City of Portland, Maine - Building or Use Permit Application 389 Congress Street, 04101, Tel: (207) 874-8703, FAX: 874-8716

Location of Construction: Meadow Ridge Condominium
 62-70 Kuryhly Lane/1502 Washington Ave., 13+14
 Owner: 44 Jaudie Development
 Phone: 797-9534

Proposed Project Description:
 Construct 2 Condominium Units

CHECK-LIST AGAINST ZONING ORDINANCE
Permit # 02-0394

JANDIE DEVELOPMENT CORP		A1
MEADOW RIDGE	DATE: 9/11/99	
CONSTRUCTION DOCUMENTS	SCALE: 1/4"=0"	
CROSS SECTION	DRAWN BY: NR	
APPROVED BY:		DATE:
APPROVED BY:		DATE:

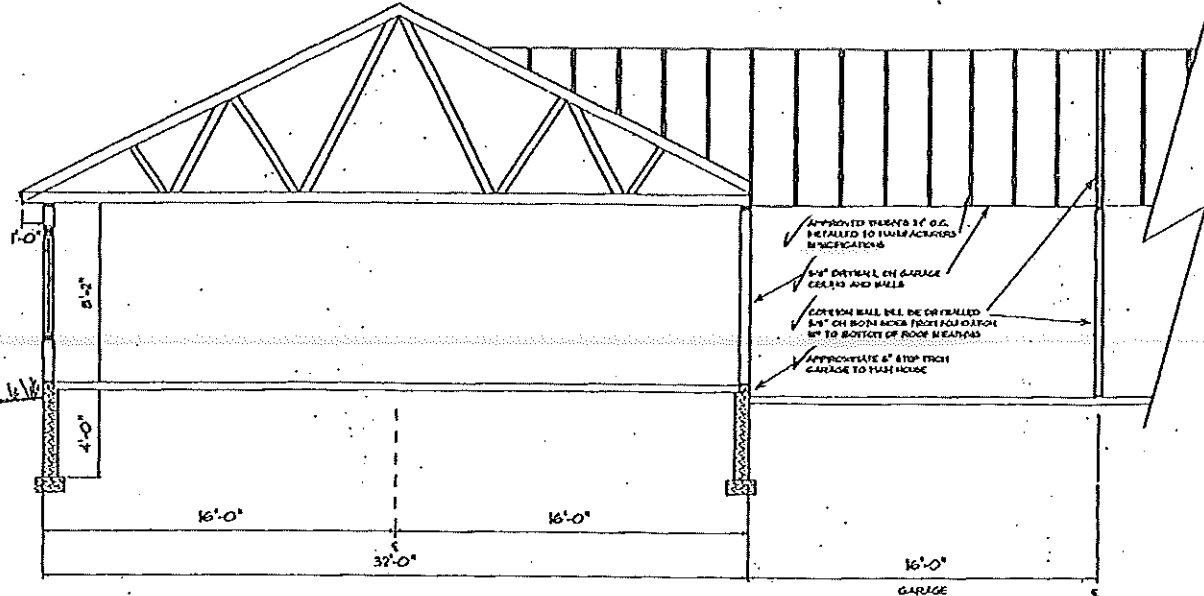
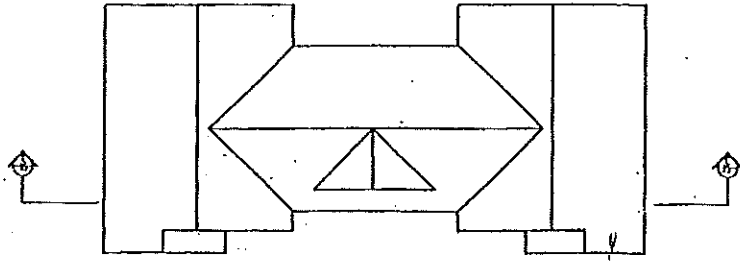
DATE	TIME	CONTACT	NARRATIVE	INITIALS
			① Smokes - Bedrooms + common area	
			② Roof Sheathing? 5/8" Min. - OSB	
			③ Headers - 3-2x8? opening?	
			④ Anchor bolts - 6' OC	
			⑤ Garage door headers + large windows	
			⑥ Gas fireplace? permits? - Will get permits	
			⑦ Framing of supports for front entrance. U	
			⑧ Steps? height - No steps.	
			⑨ Egress windows. - In all bedrooms.	
			Page - 95 - headers -	
4/29/02			Left message for Janice Dev. to call.	TM
			2'-2x10' - 8'-10" opening w/gauge - will do an engineered beam.	
			Centered brusses.	
4/29/02			Spoke w/Andy DeLice - went over all of the above - Agreed to do all of them.	
4-30-			Also agreed to install an engineered beam above garage door opening do to excessive load being carried.
